1 **ADDENDUM NO. 1 (Rev 1/2023)**

2 **ISSUE DATE: October 20, 2023**

3  
4 **RE: Williams Fieldhouse Seating Renovation**  
5 **University of Wisconsin, Platteville - Athletics Department**  
6 **Platteville, Wisconsin**  
7

8  
9 Division Project No. **H-22-001**

UWSA Number: H-22-001  
MSN Number:  
Set Type: BD  
Date Issued: 09/20/2023  
Sheet Number: **A101**

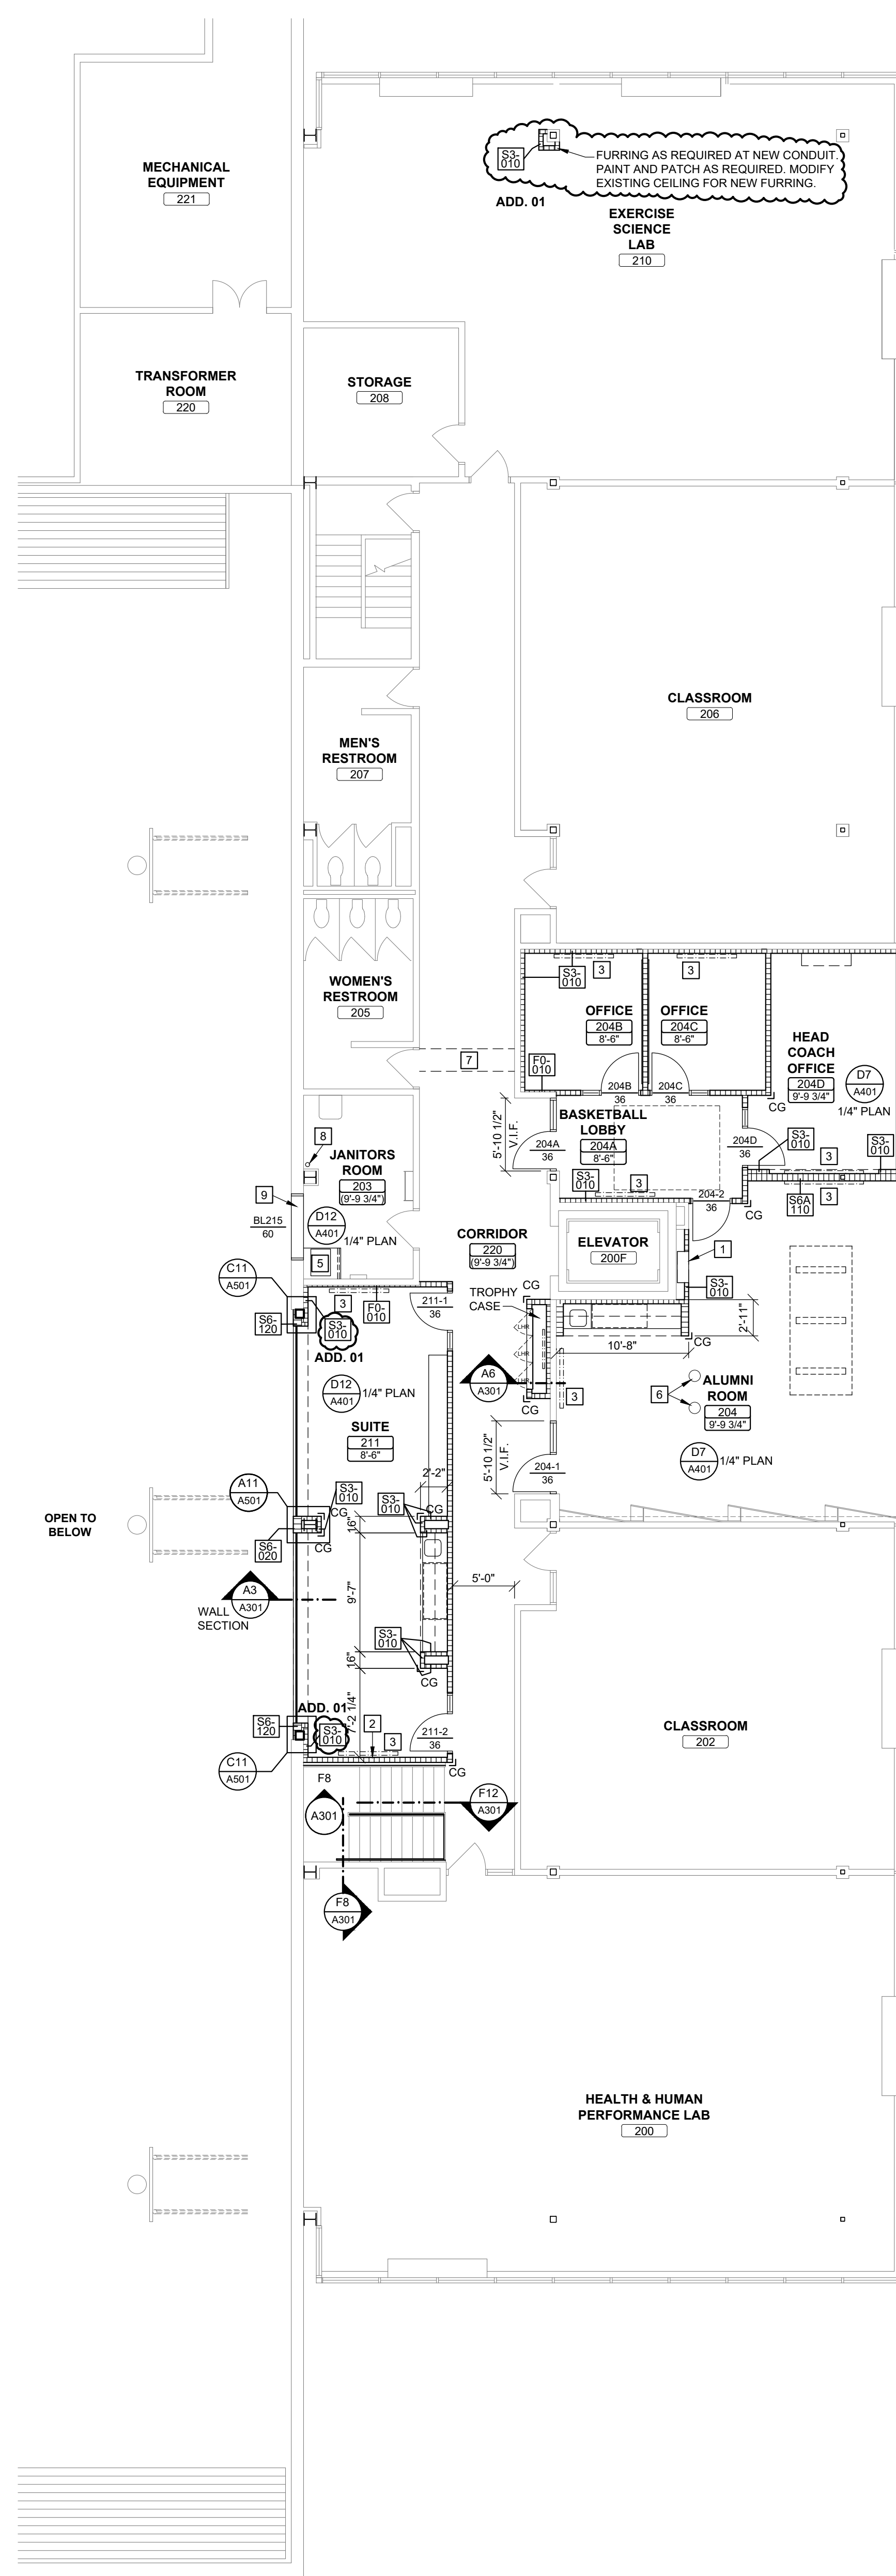
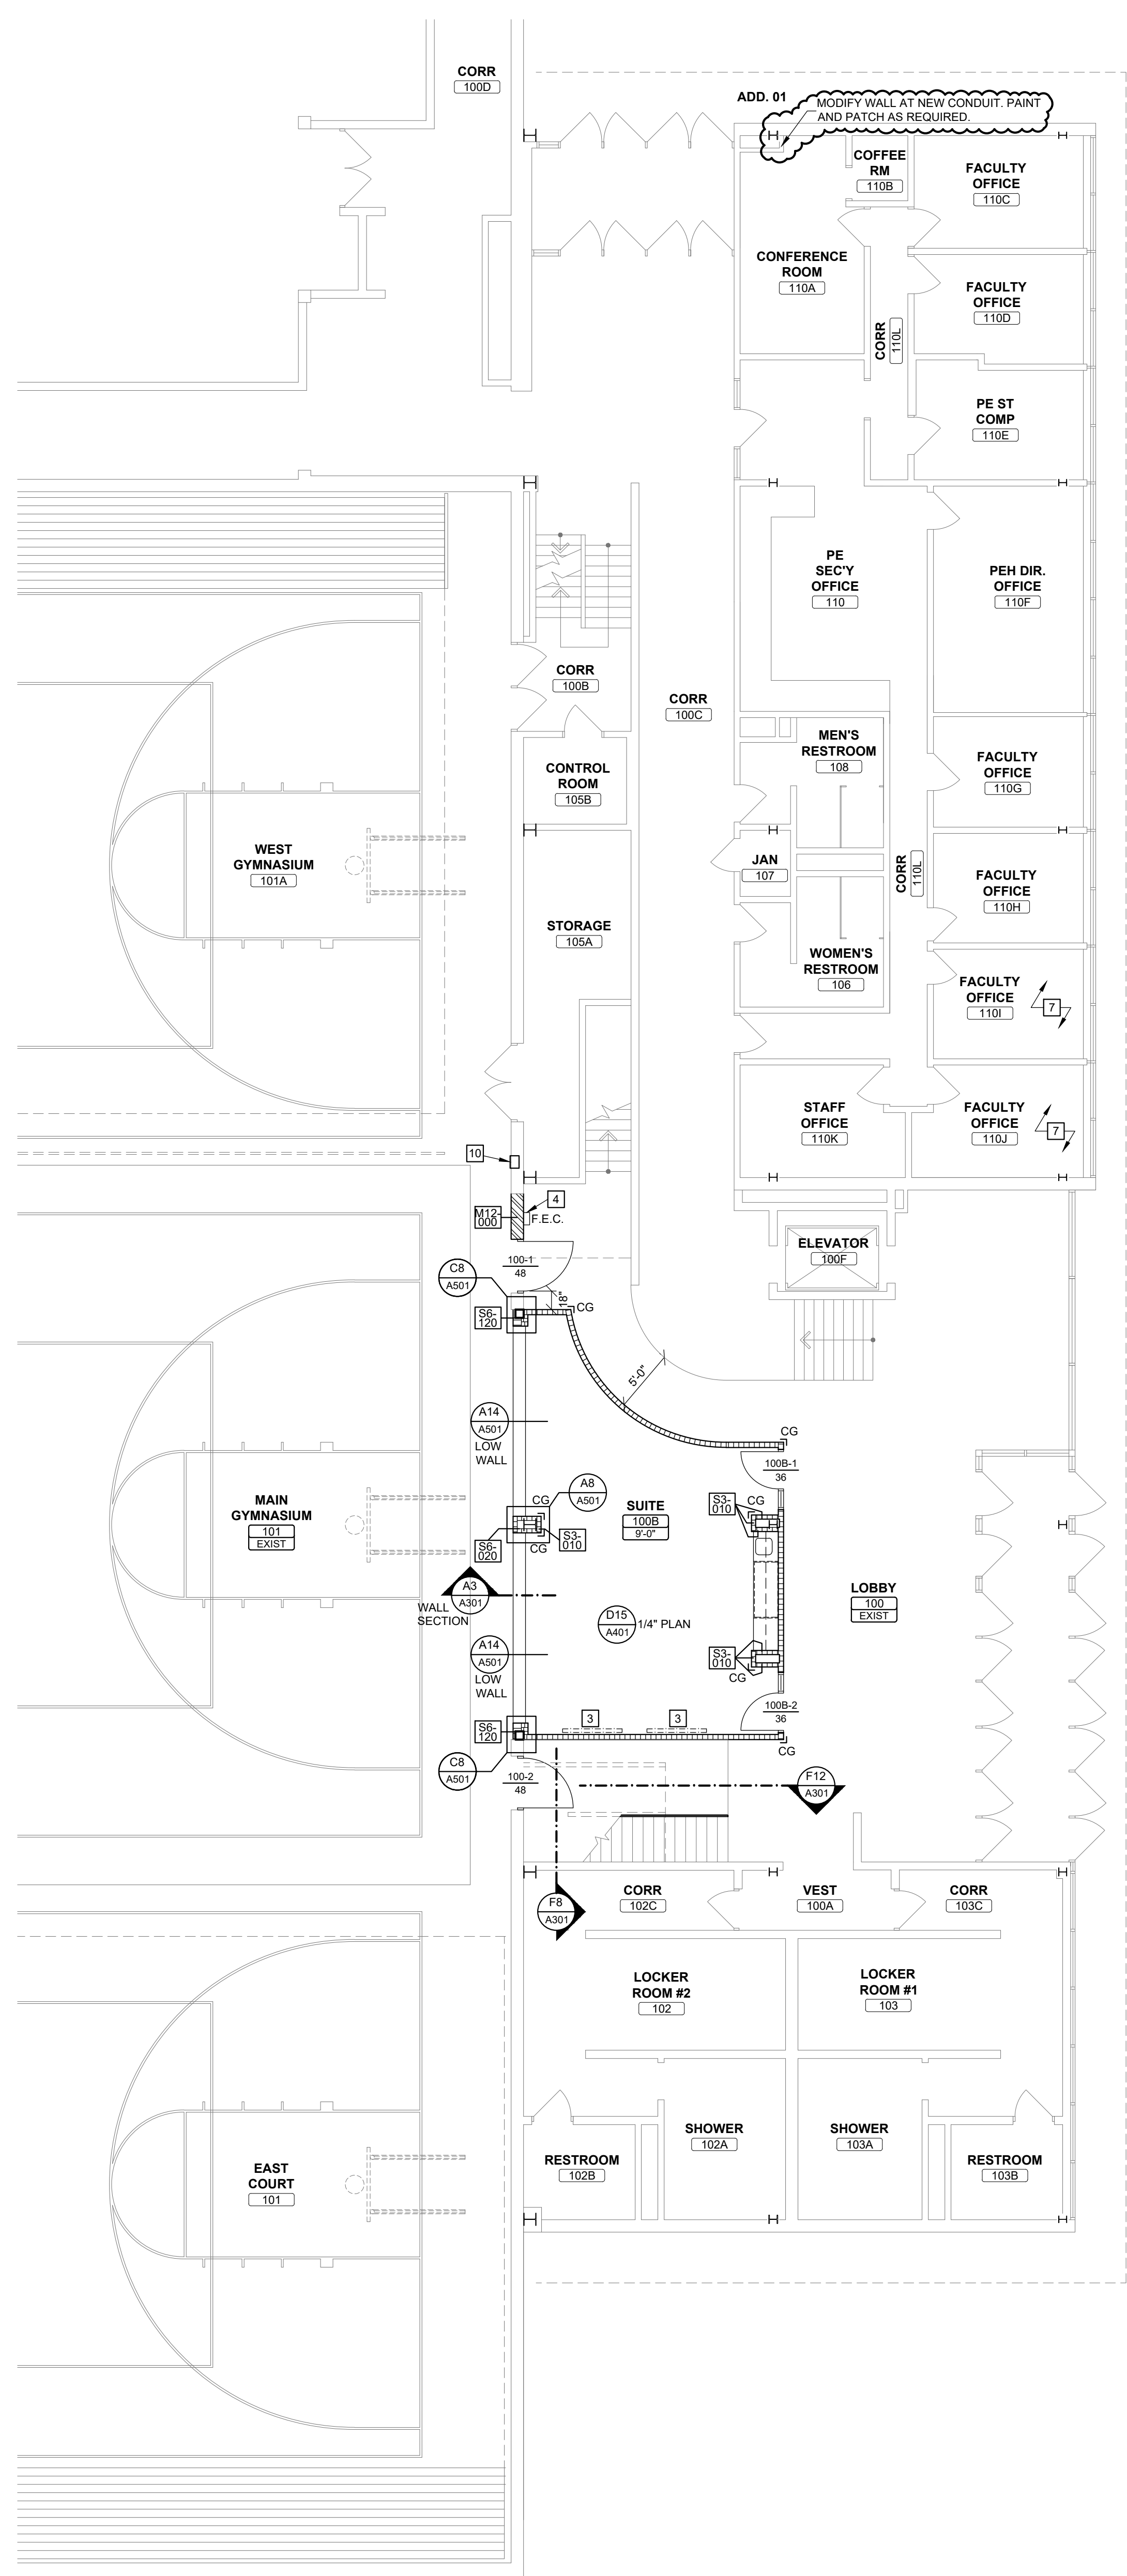
52  
53 1. Drawings A101 NEW WORK PLANS and AR101 REFLECTED CEILING PLANS

- 56  
57 1. At first floor, modifying and patching existing wall for installation of added conduit.
- 58 2. At second floor, adding furring to enclose conduit.
- 59 3. Added clarification of furring type on second floor.
